218 Railway Parade, Noble Park
Draft concept plan for new pocket park
CONSULTATION SUMMARY REPORT

218 Railway Parade Draft Concept Plan

COUNCIL'S RESPONSE TO CONSULTATION OUTCOMES

Draft concept plan

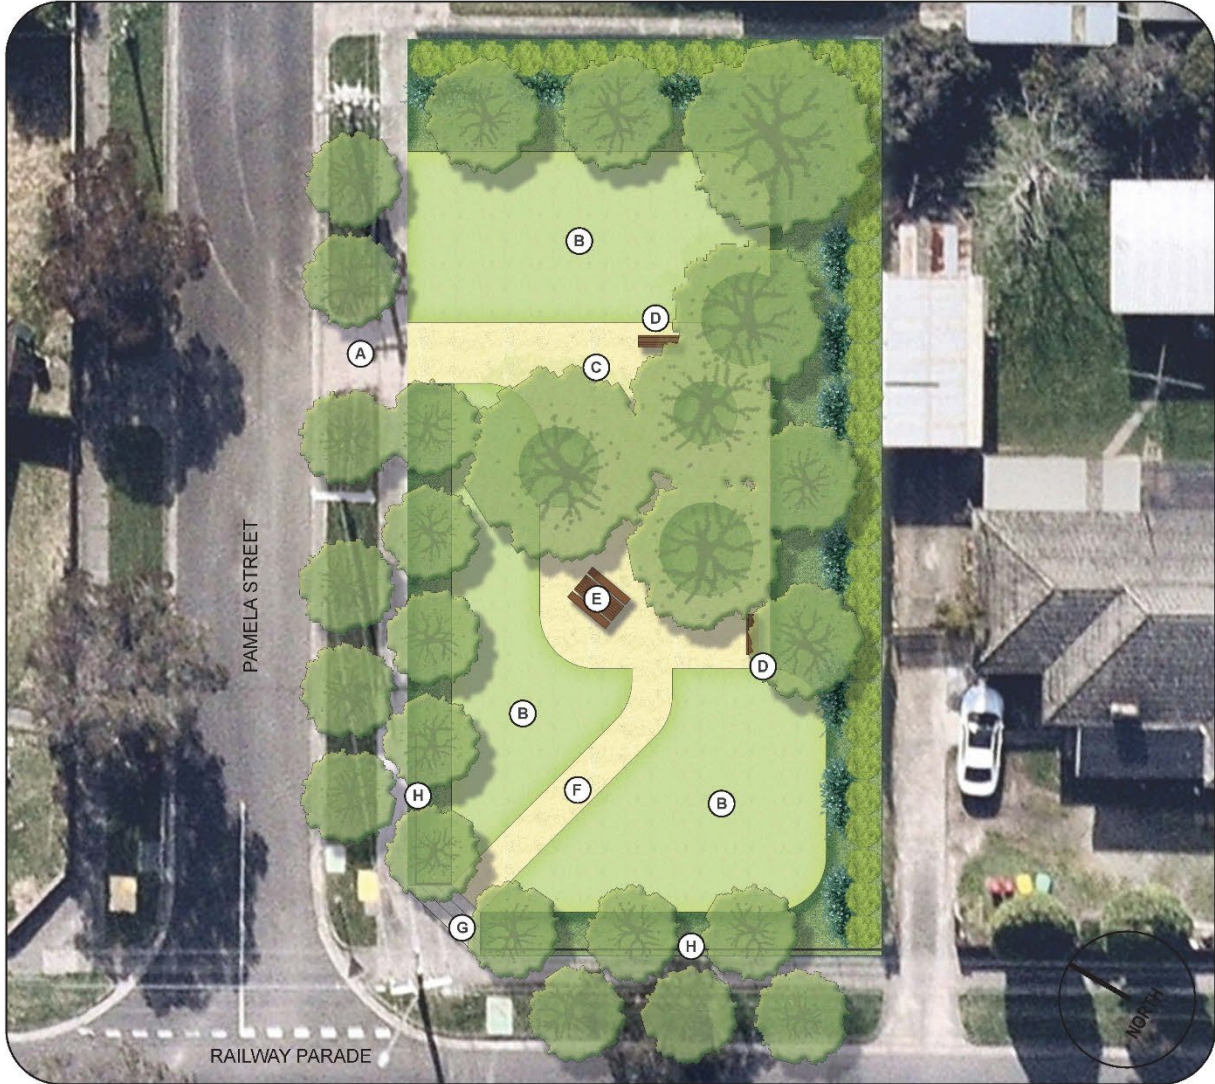
- *That they don't plan to keep the existing trees on site is very poor, particularly as they carefully saved them in the process of demolishing the buildings on the site. It may be a mistake in the concept design but I am concerned it is not so it is worth pointing out in my view..... Nothing about the design is particularly interesting is a problem in both continuing support for this open space acquisition program but more importantly attracting people to the space.....*

- *I am writing as I'm concerned that the existing trees will be removed. How wonderful if the concept could be designed around the trees. It will be bleak without them. Public spaces must retain trees to soften a landscape and cool the area especially in summer. They also add interest.*

- *I don't think 1 picnic table is enough. If one family or person sits there then there's no other one for another visitor to use. Please have a minimum of two picnic tables*

- Retaining the existing trees
- Providing activities for all age groups – especially families and children
- A small playground / small number of playground equipment pieces
- Provide infrastructure such as a picnic table setting and seats
- Enhance the park's landscape amenity and biodiversity.
- Retain clear sight lines into the park for passive surveillance

Comment Themes	Council officer response
Retain the existing trees	The revised concept plan retains the existing trees on the site and integrates them with the new trees.
More trees and indigenous planting Increase the number of shade trees	The revised concept plan includes the increase in tree planting across the park as well as garden beds.
Small amount of playground equipment There was strong support for including a small amount	It is acknowledged that the provision of some playground equipment was of high importance.
